SCS ENGINEERS

Subject: Response to Request for Additional Information No. 3 (RAI No. 3)
Citrus County Central Class I Landfill Operation Permit Renewal
Pending Permit No.: 21375-018-S0/01, Citrus County
WACS No: SWD/09/39859

Water Quality and Leachate Monitoring Plan

Central Landfill Citrus County, Florida

ATTACHMENT 1 SITE PLAN
CITRUS COUNTY CENTRAL LANDFILL

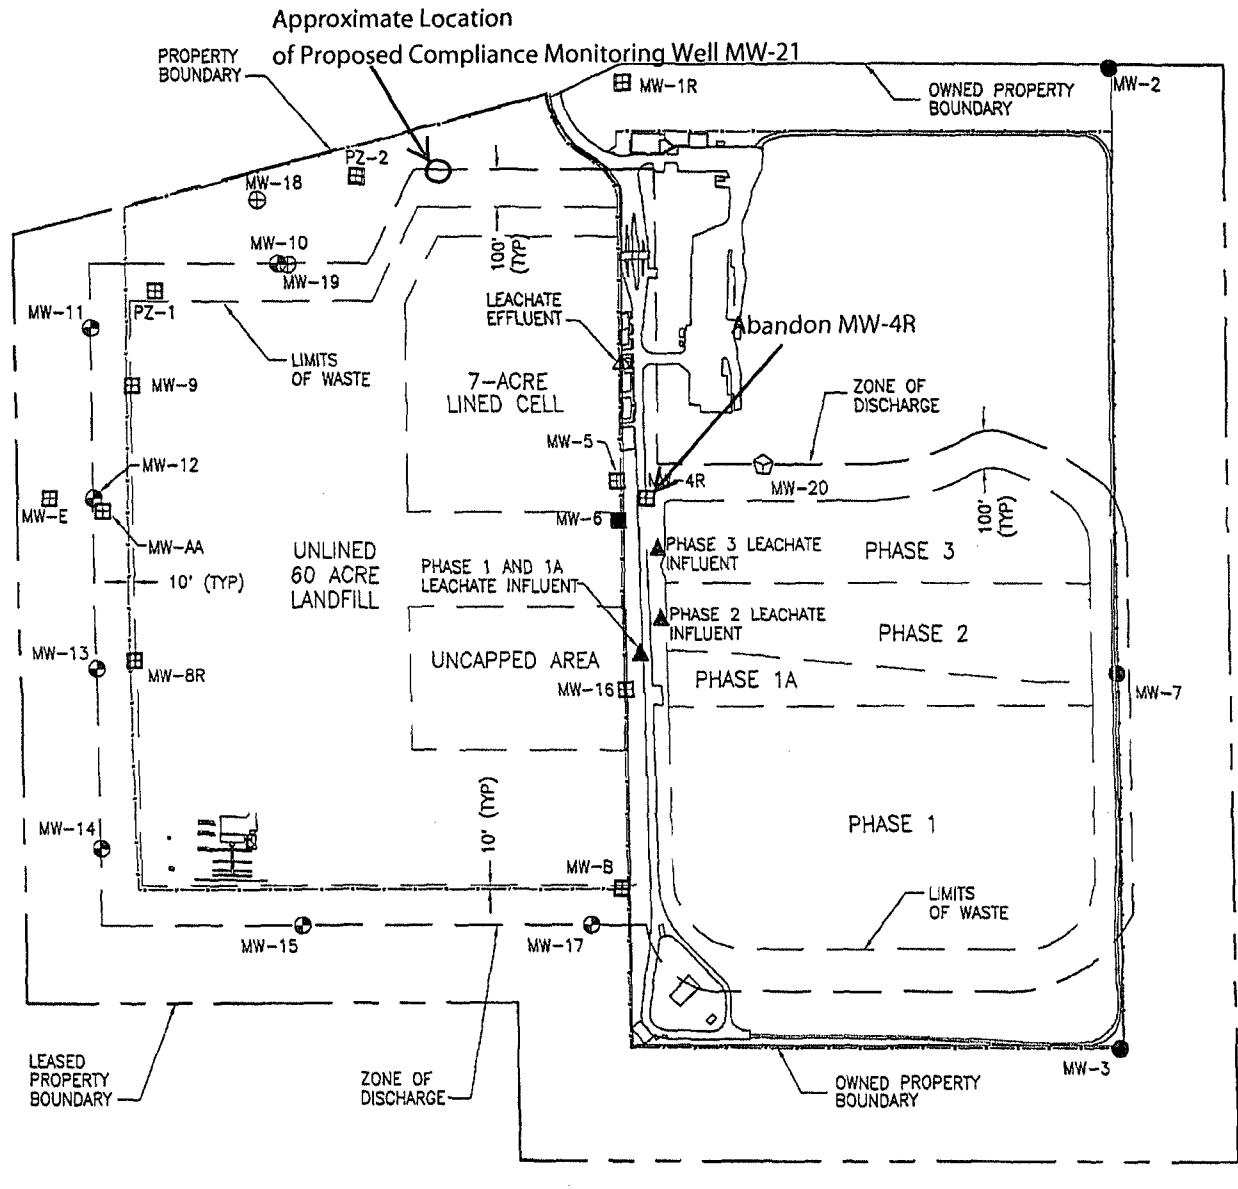
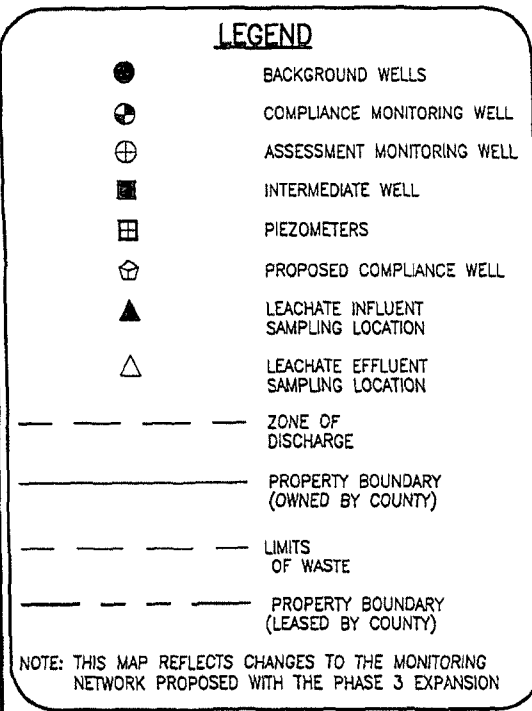
2) The third sentence of this section referred to the well locations on “Figure 2 of the Monitoring Plan.” Please submit revisions to refer to Attachment 1 of the WQLMP document.

4) The third sentence in ¶1 of this section referred to the well locations on “Figure 2 of the Monitoring Plan.” Please submit revisions to refer to Attachment 1 of the WQLMP document.

Response: Section L.1.c.2 has been revised to refer to Attachment 1 of the WQLMP document.

Response: Section L.1.c.4 was revised to refer to Attachment 1 of the WQLMP document.

Modified by SCS Engineers to add proposed compliance monitoring well location and proposed piezometer abandonment-
September 22, 2010
